**Addendum #1 for
RFCSP752-25-1012CS
Kerr Hall Dining
(Treanor's Addendum #4 for
the project)**

ADDENDUM NO. 4

PROJECT: UNT Kerr Hall Dining Renovation
HE0569.2302.01

DATE: 07/03/2025

OPENING WIDTH	ANGLE SIZE
UP TO 4'-0"	L3x3x1/4
4'-0" TO 6'-0"	L5x3x1/4 (LLV)
6'-0" TO 8'-0"	L6x3-1/2x5/16 (LLV)

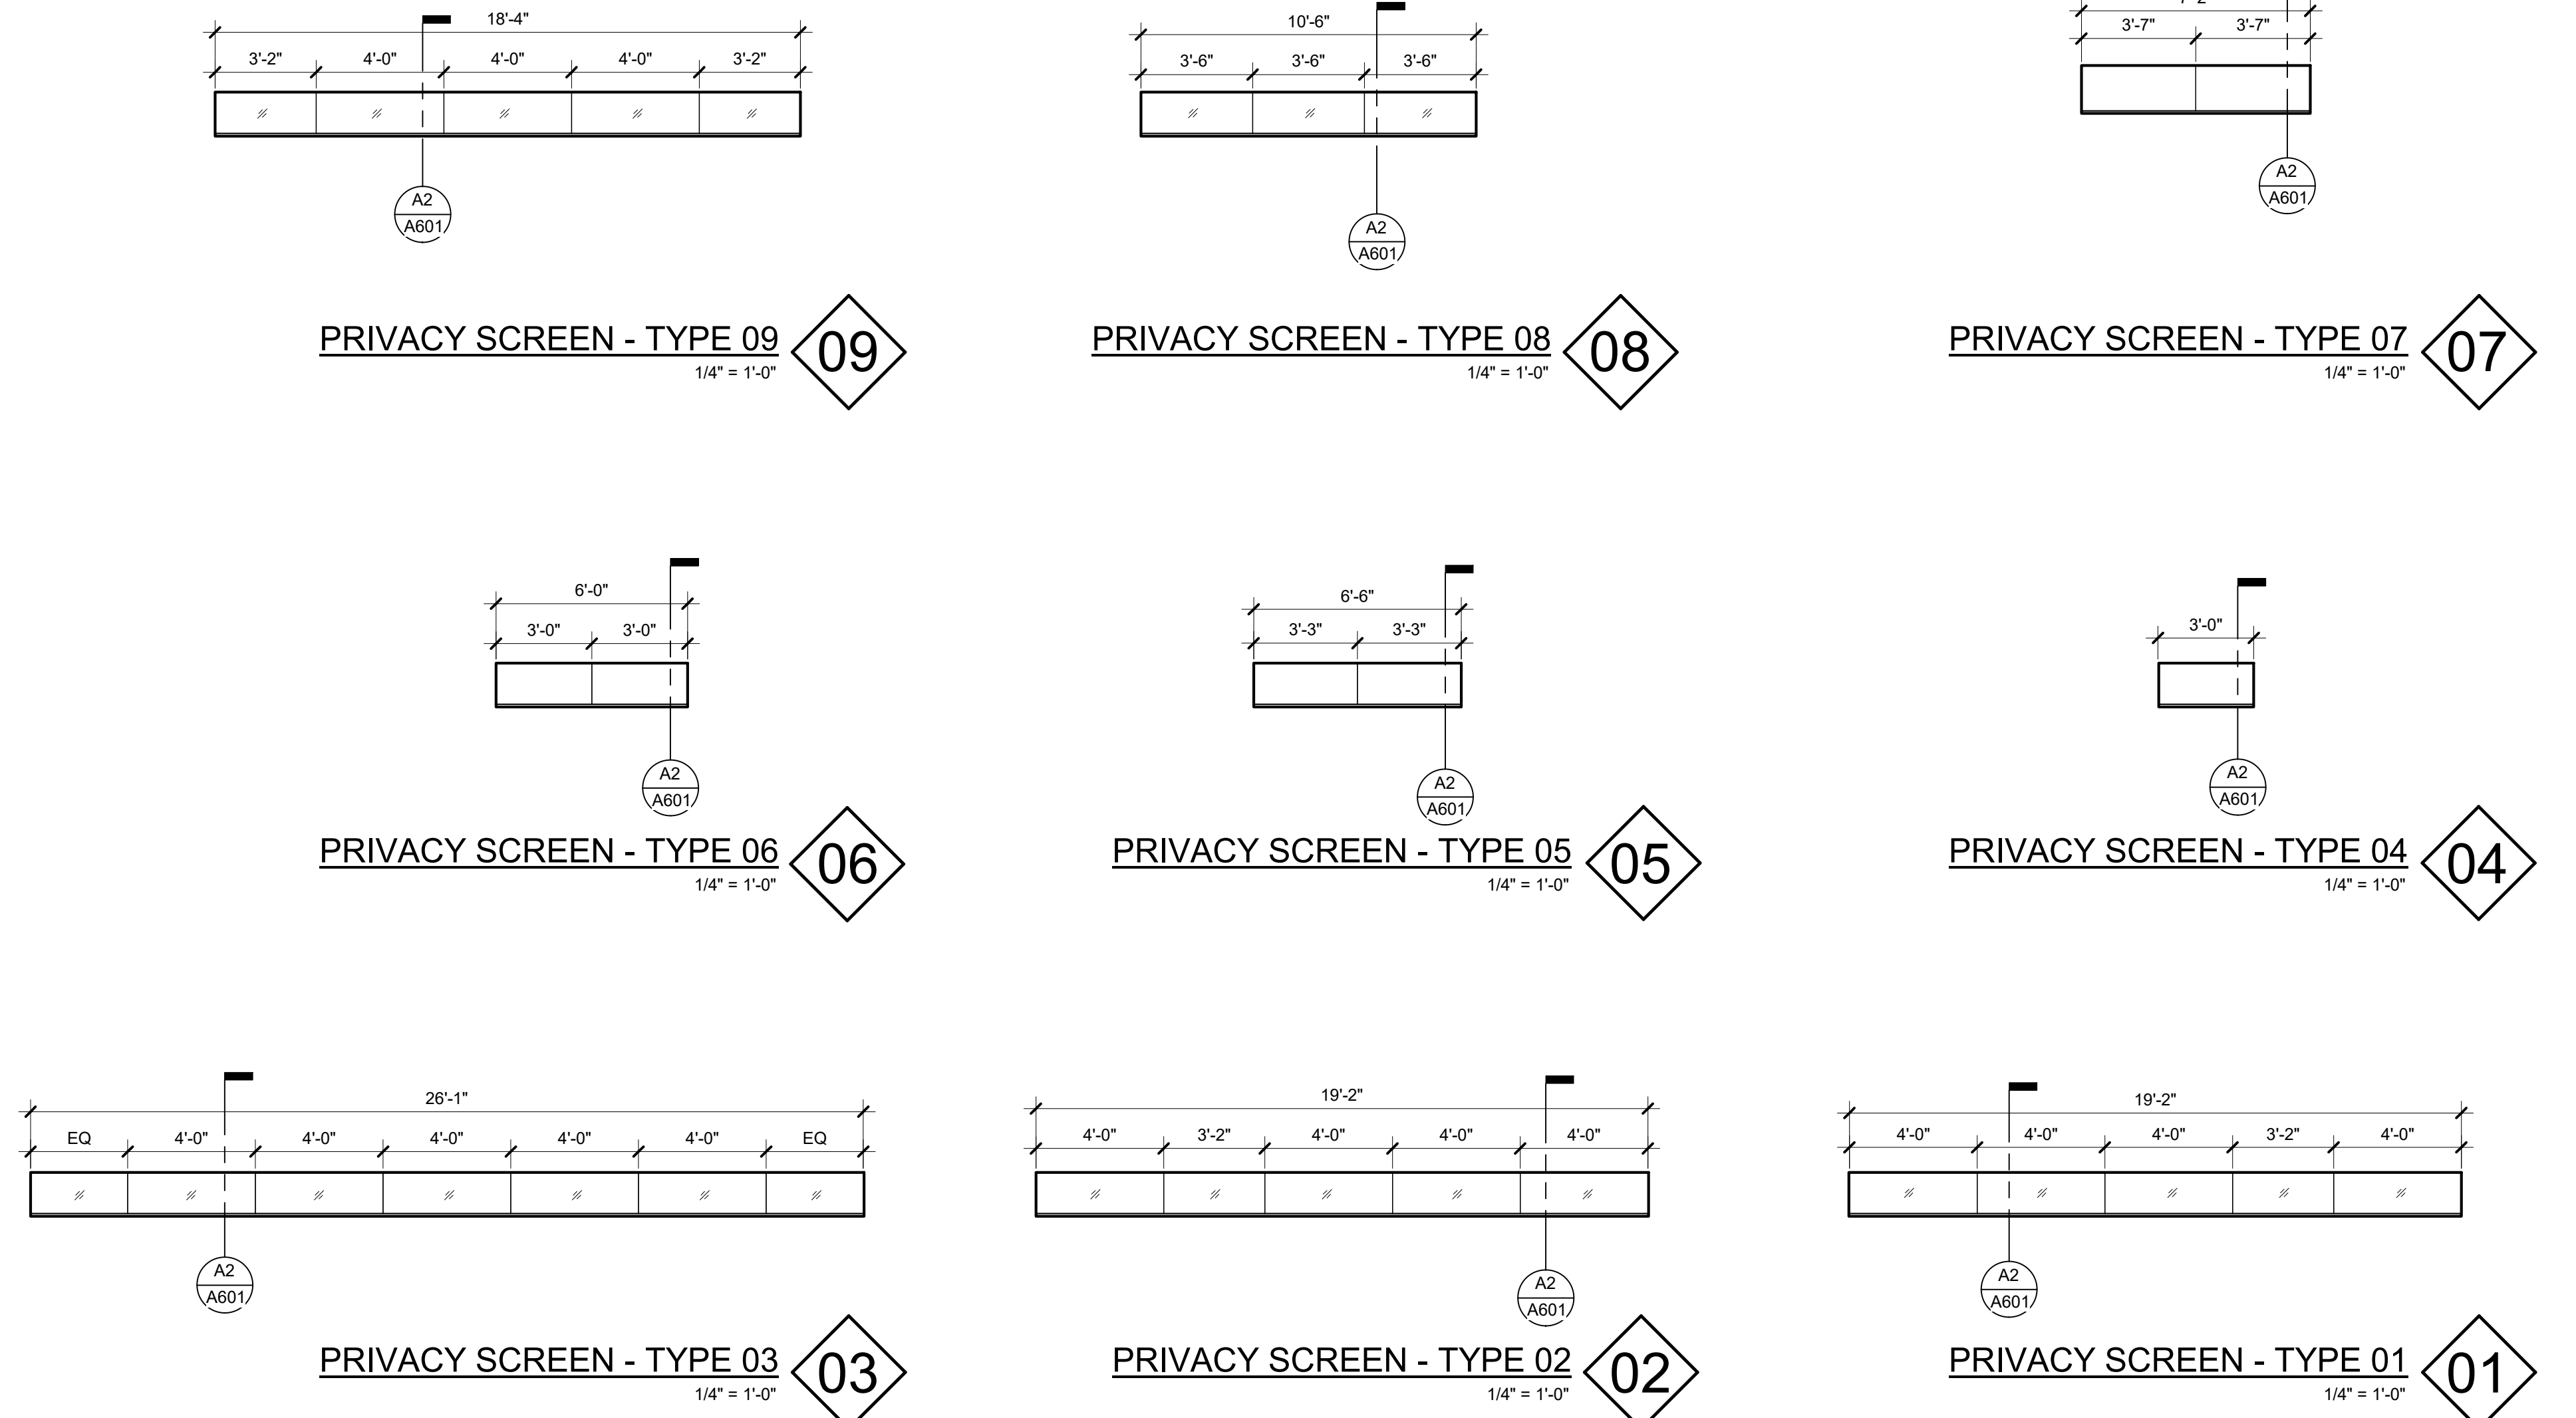
29. Door schedule calls for door A140 to be 3'-0" by 6'-10", while detail B3/A406 calls for a 3' by 7' door. Please verify the correct door size.
The hydroponics enclosure door is 3'-0" x 7'-0" tall as detail B3/A406 indicates. The discrepancy in the door schedule has been corrected.

- A601 – DOOR & FRAME SCHEDULE, GLAZING TYPES, LOUVER TYPES, & DETAILS
 - B2/A601 added clarifying the base bid condition at pony walls without the privacy screens (Alternate #3).

- Door A140 corrected to be 7'-0" tall in the door schedule.
- A700 – INTERIOR FINISH LEGEND, SCHEDULE, & DETAILS
 - PT-6 removed from finish legend.
 - TL-9 basis of design added to finish legend.

TYP. CONCRETE PATCHING DETAIL (ON GRADE) D1

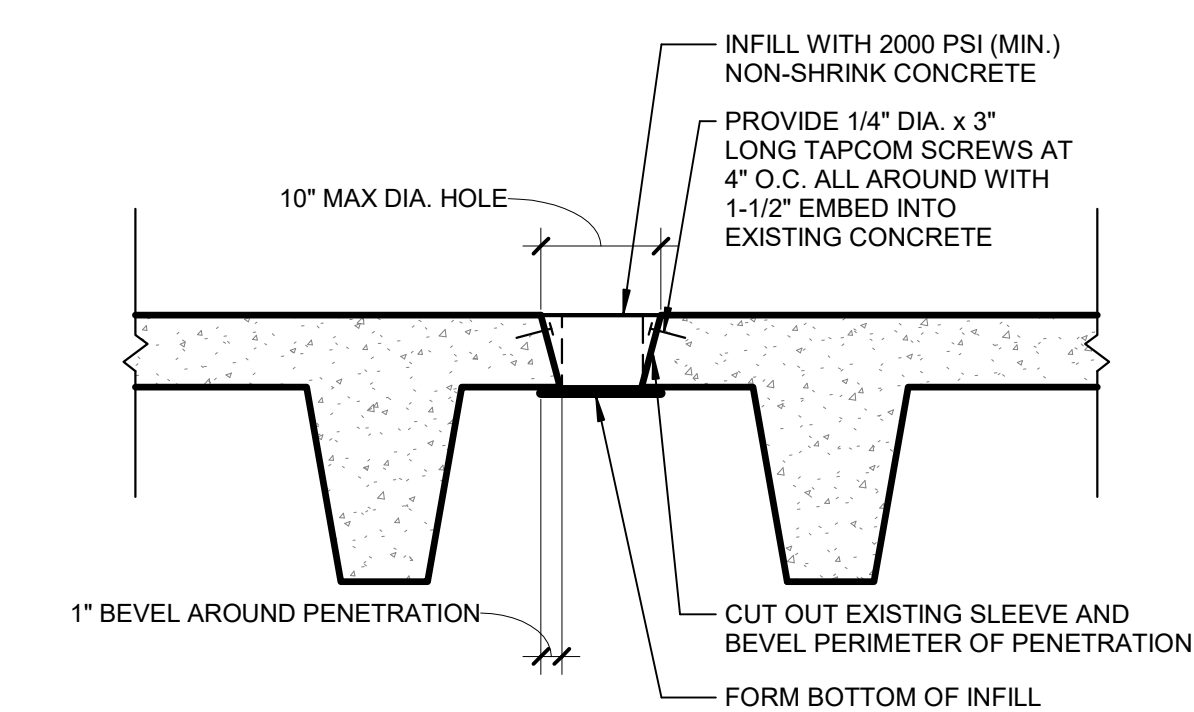
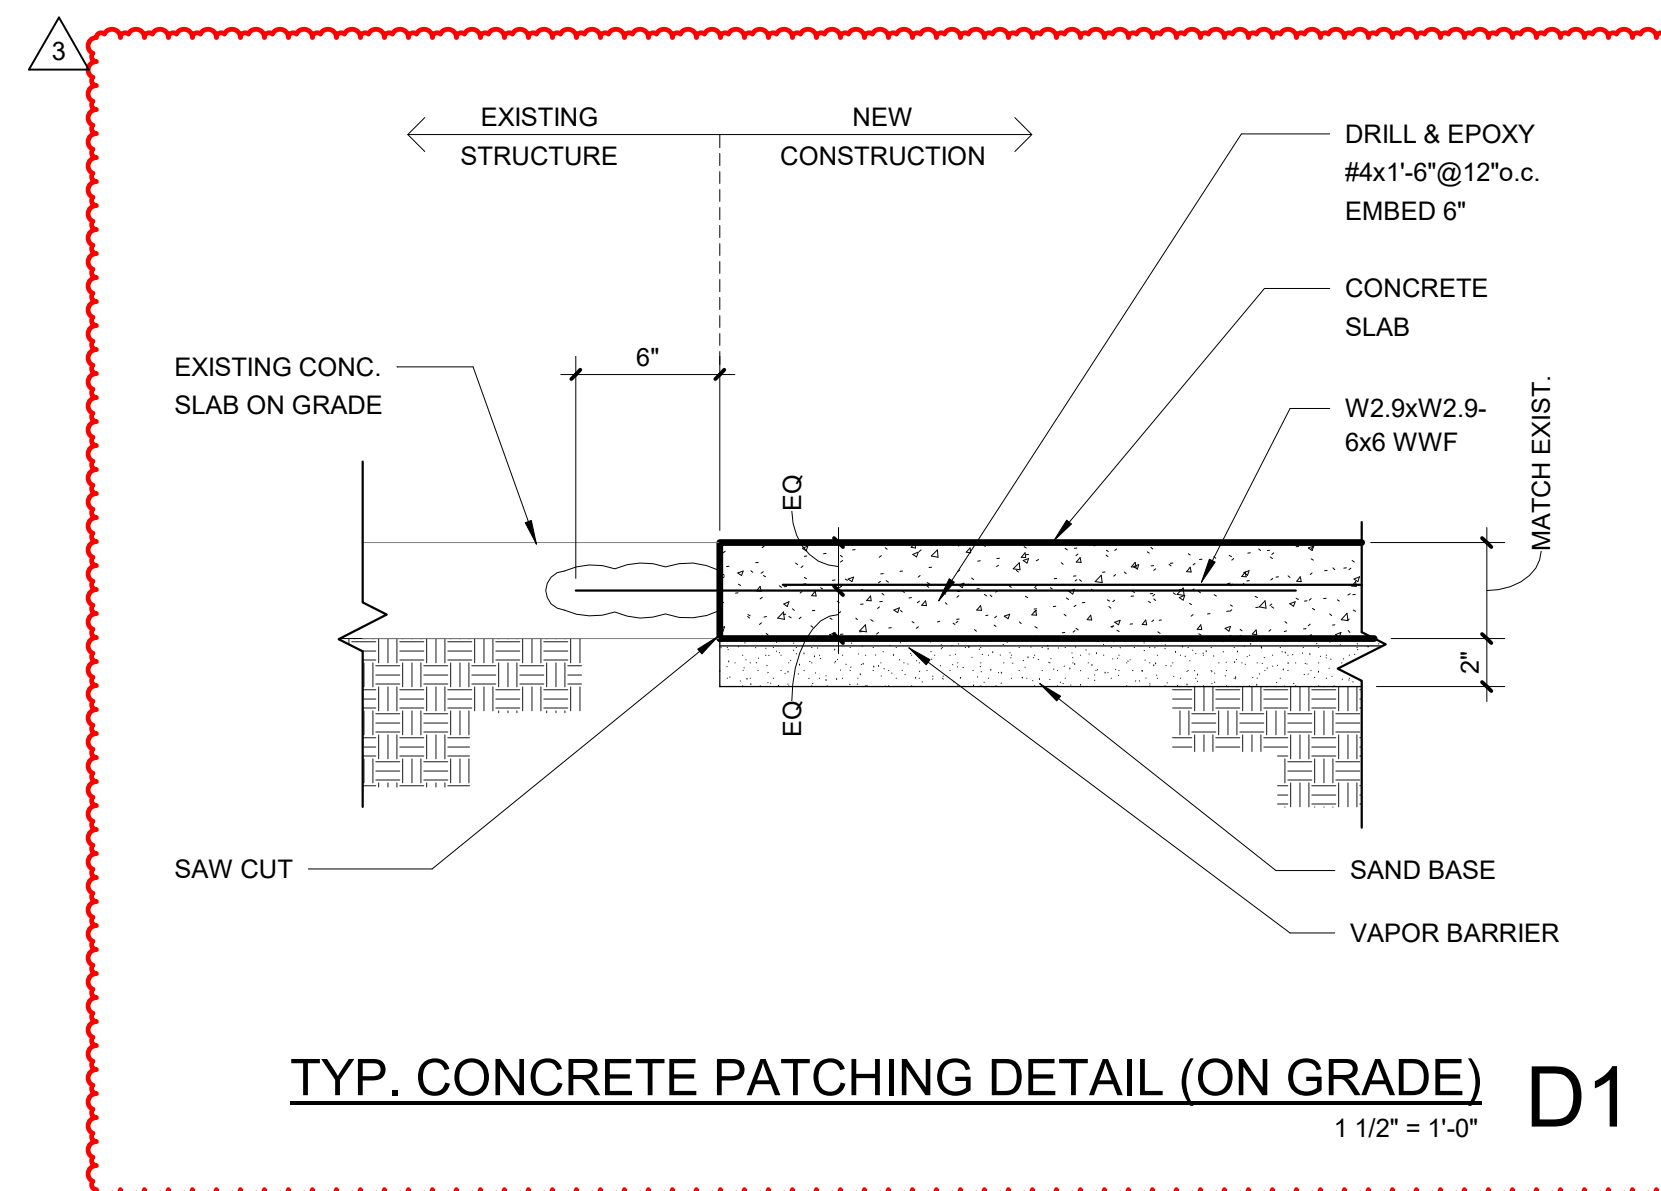
ITEM	DETAIL
7.	<p>Please provide concrete infill details with reinforcement for the slab infill required at the demoed floor diffusers indicated in RFI #73 response. This detail was not included in any of the addenda.</p> <p>Reference details on sheet A700.</p>

8.	<p>Please provide concrete patching detail at demoed floor drains referenced in RFI #39 response. It was not included in any of the addenda.</p> <p>Reference details on sheet A700.</p>

9.	<p>Please provide concrete patching detail at damaged concrete referenced in RFI #40 response. It was not included in any of the addenda.</p> <p>Reference details on sheet A700.</p>

- Scope of alternate/base bid condition of Alternate #2 clarified in ROOM BY ROOM FINISH SCHEDULE.
 - D1/A700 added.
- A701 – FINISH PLAN
 - Extent of TL-5 changed at Dish Return A126.

① ONE-LINE DIAGRAM
NOT TO SCALE

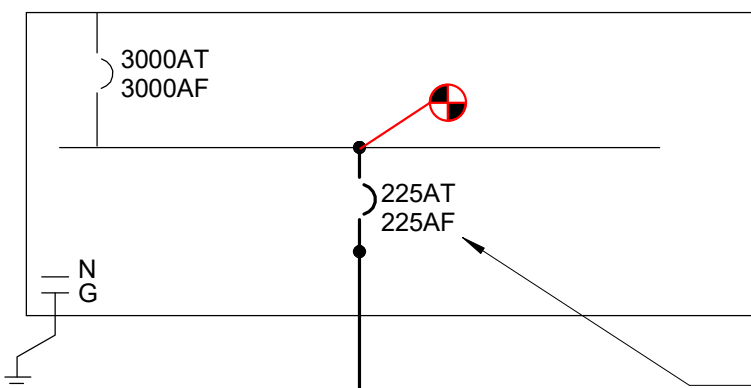
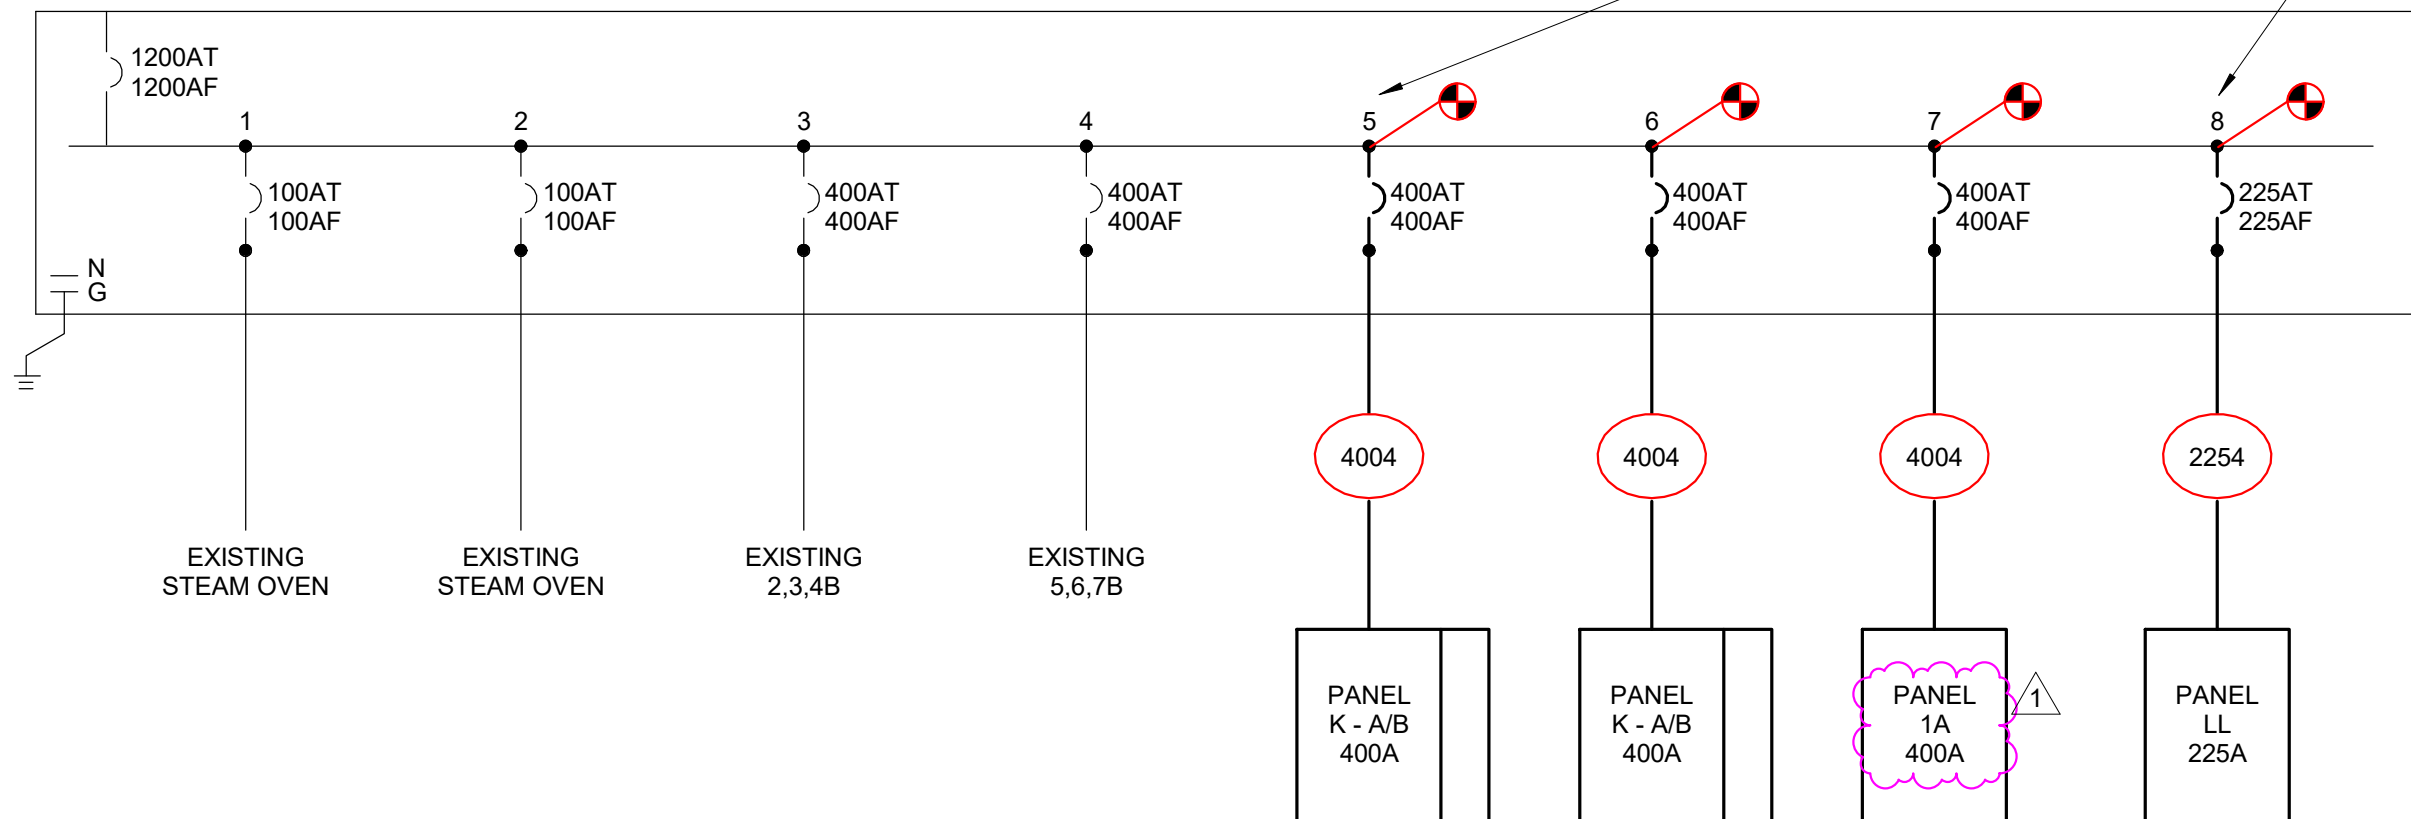
32. Please advise where electrical panels LA and LL are located and provide panel schedules for them. They are shown on the electrical one-line diagram on sheet iE501 but not shown on the electrical floor plans or the electrical panel schedules on sheet iE803. **Panels are shown on one-line diagram for reference only, providing a summary of the various panels served by existing switchboard MSBB in the building. Panel LL serves the adjacent laundry room and is not utilized in this project. Panel 'LA' is a typo and should actually read '1A.' This typo has been corrected.**
